RE: Recall 04V080

**VEHICLE SAFETY DEFECT SERVICE BULLETIN**  
**Recall Campaign No. 04V080000**  
**Monaco File # R04001**

**Re: Recall-Villa International Belt Buckle Mount**

### Recall 04V080000 Villa Seat Pedestal

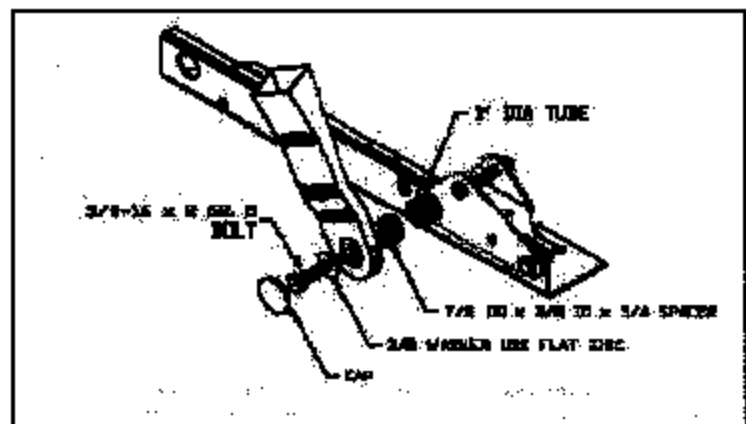
1. Remove cap and loosen existing bolt to remove belt buckle.

2. Insert 7/8 OD, X 3/8 ID, X 1/4 Spacer into 1" DIA. Tube.
3. Re-install belt buckle with 3/8 USS flat washer zinc & 3/8 - 16 X 2 grade 5 hex bolt.
4. Tighten bolt to 30 ft.lbs. & Replace cap
